**Iron Horse Golf Course Improvements Project  
North Richland Hills, Texas**

**RFB 20-002- SEPTEMBER 18, 2019**

**ADDENDUM NO. 3**

**ADDENDUM NO. 4**

**ADD THE TWO ATTACHMENTS: IHR-EX IRR SCAN 1 AND IHR-EX IRR SCAN 2.**

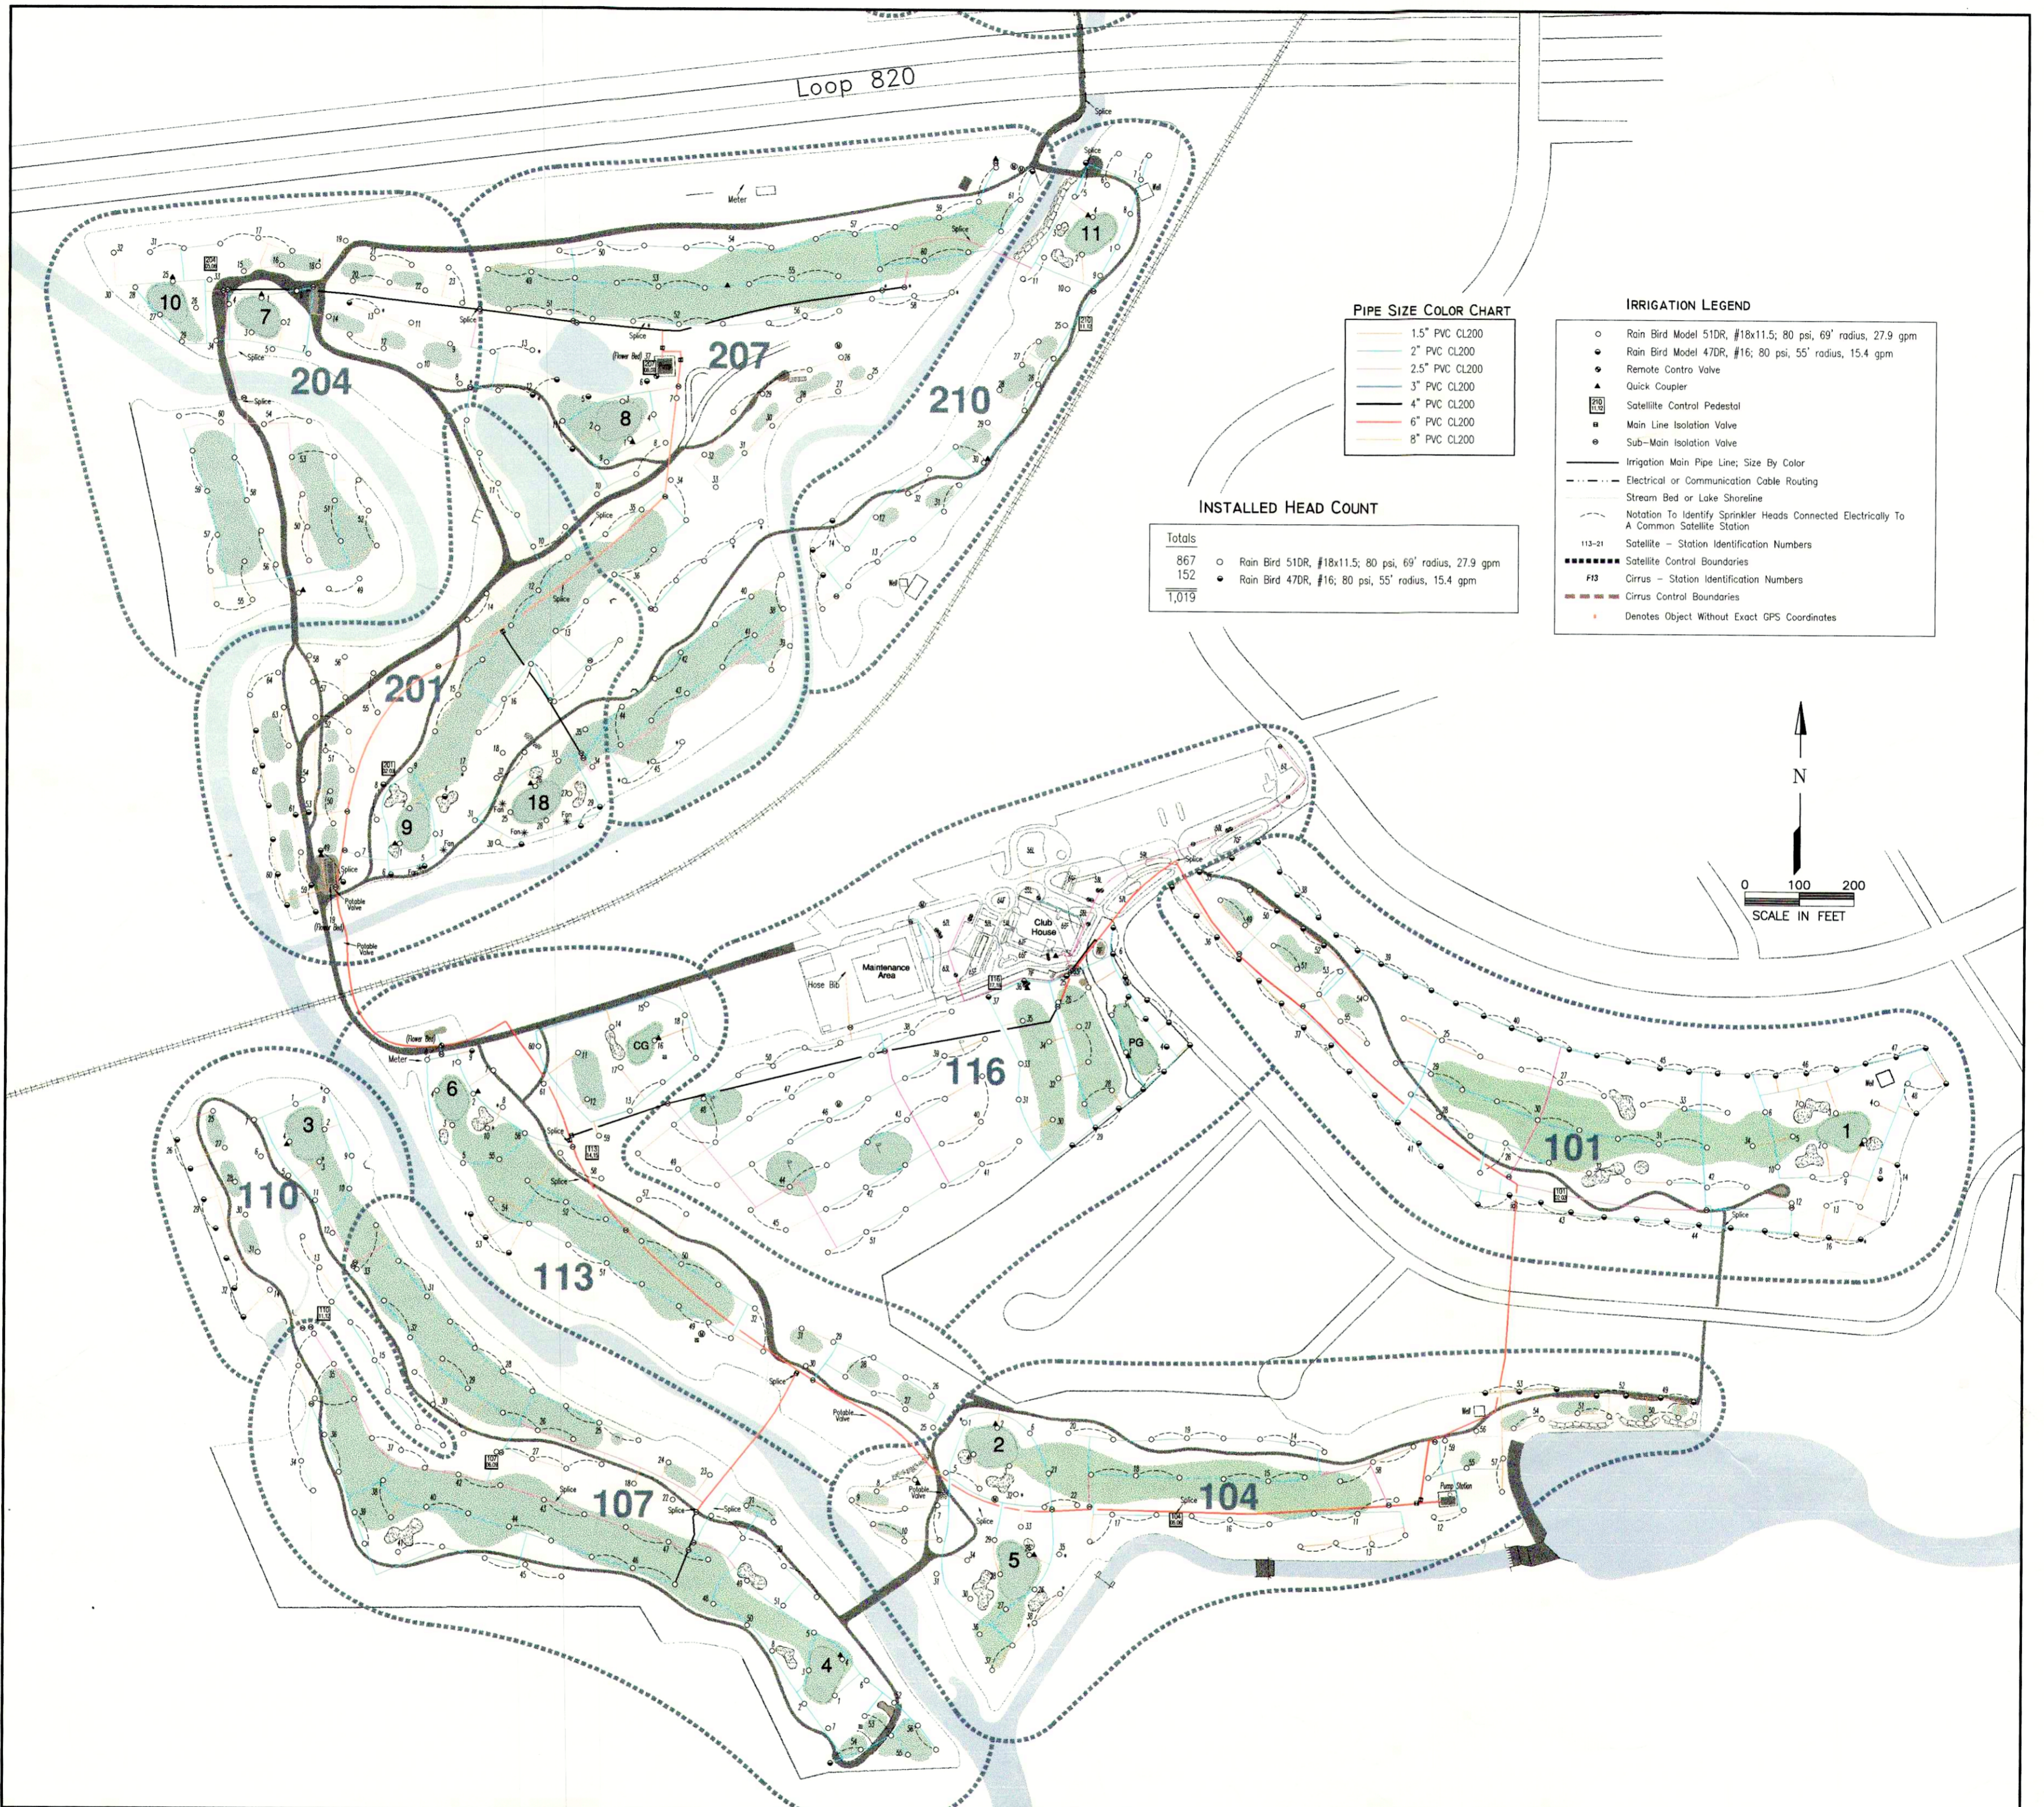
*Regardless of irrigation sprinklers/ the control system specified and chosen, Contractor will use Rainbird Maxi Control Cable.*

**ADD THE ATTACHMENT: ADDENDUM 4 DETAIL LOW WATER CROSSING MULTIPLE PIPE INLET**

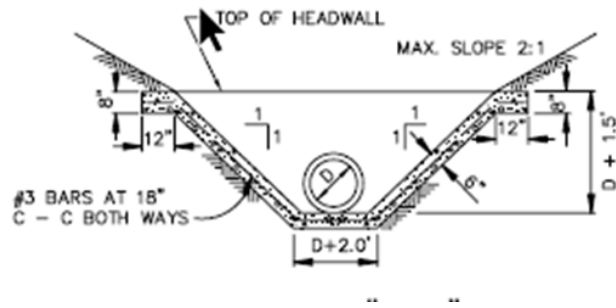
SINGLE PIPE INLET AT 16 GREEN (ABOVE) CONCRETE AT SAME SPEC AS CART PATH

- NOTE: HEADWALL CONTAINING PIPE ALSO SLOPED BACK AT APPROX 2:1 SLOPE AS SIDE SLOPES

FOR 4x 36" PIPE CROSSING AT HOLE 13 –

- USE DETAIL ABOVE, PLUS
- PIPES MUST BE ALL ALSO BE SPACED AT DIAMETER + 2 FEET.
